Date: 19 February 2008  
To: T10 Technical Committee  
From: Ralph O. Weber  
Subject: SPC-4 UML Conventions and CbCS UML Updates

07-430r2 (UML model for CbCS) added the first UML diagram to SPC-4 but did not specify the contents of the Conventions subclause for UML.

Figure 11 — CbCS overview class diagram

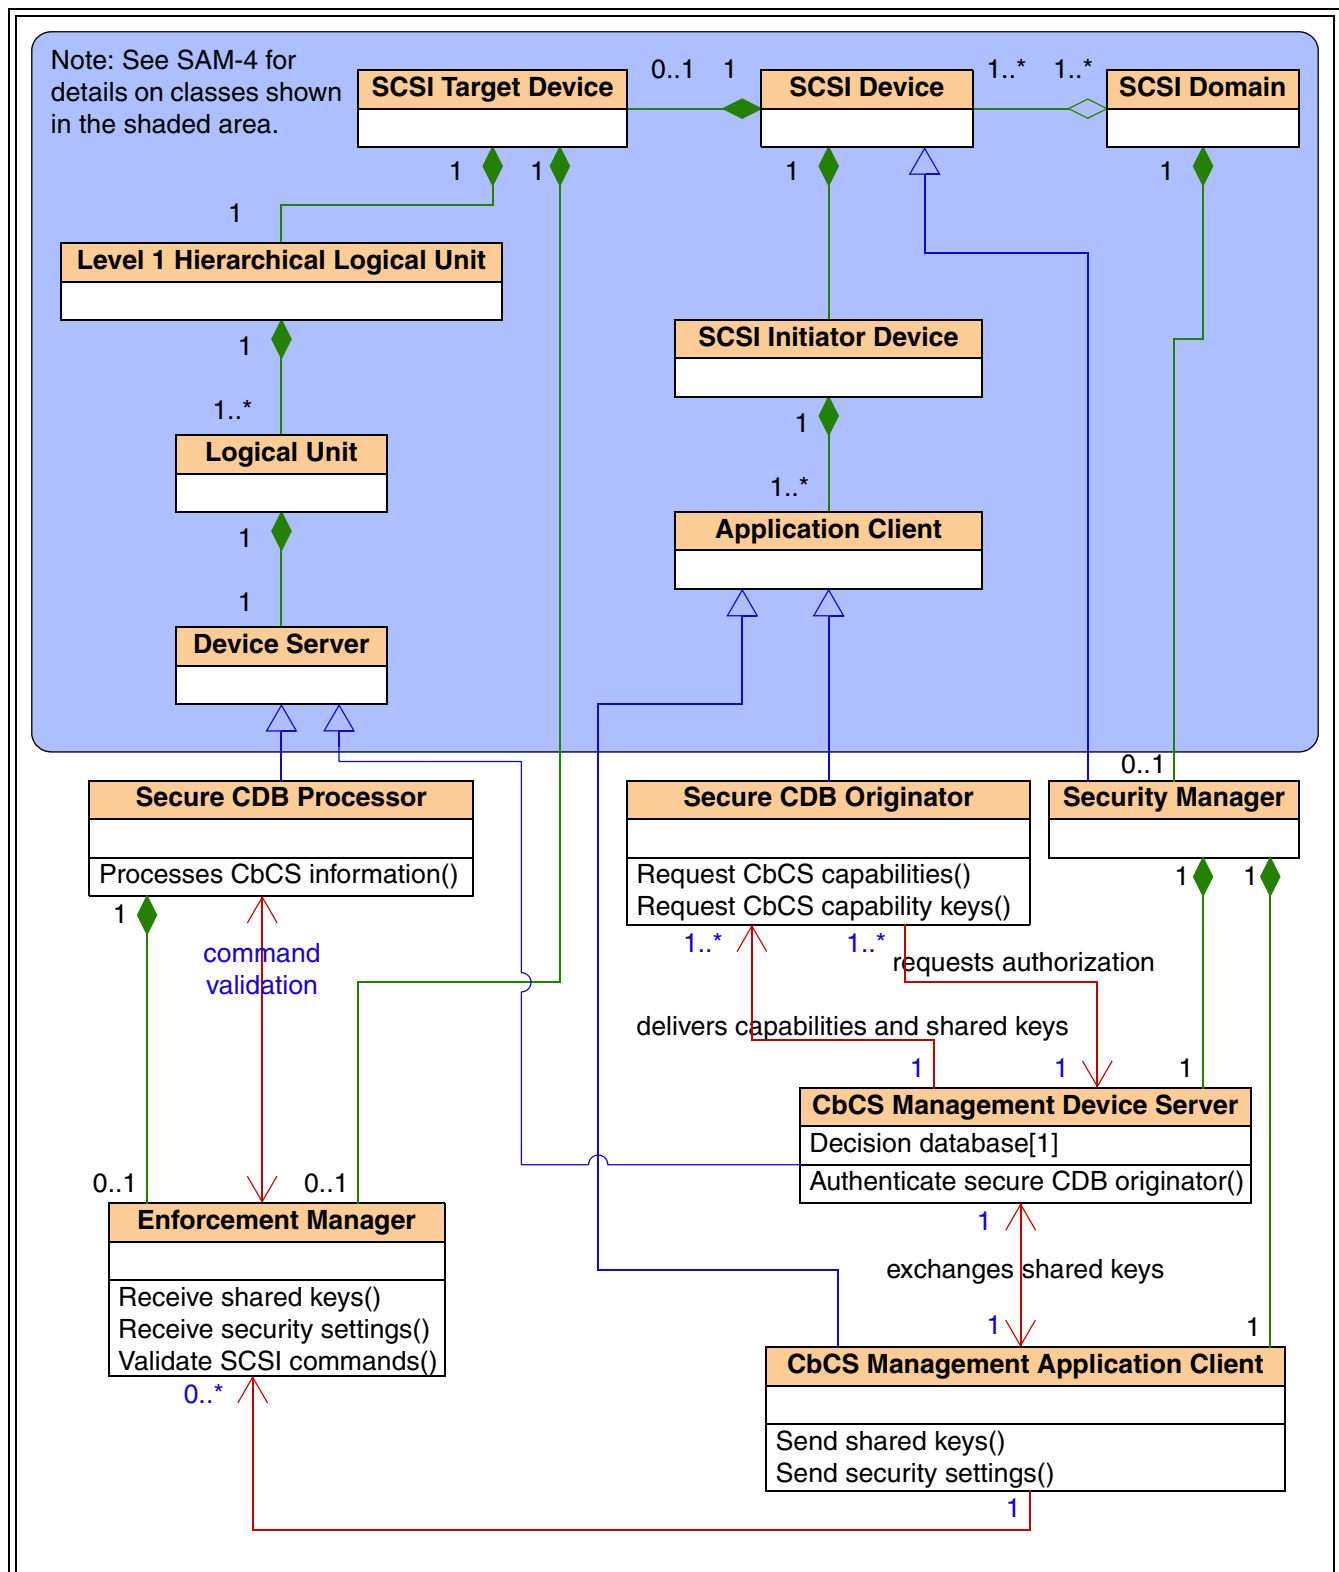
Also, the CbCS UML lacks the required multiplicity notations, and they are proposed here.

Except for figure 11, all changes in this proposal represent new SPC-4 text. In figure 11, additions are shown in blue text, there are no deletions proposed. Comments are shown in green text.
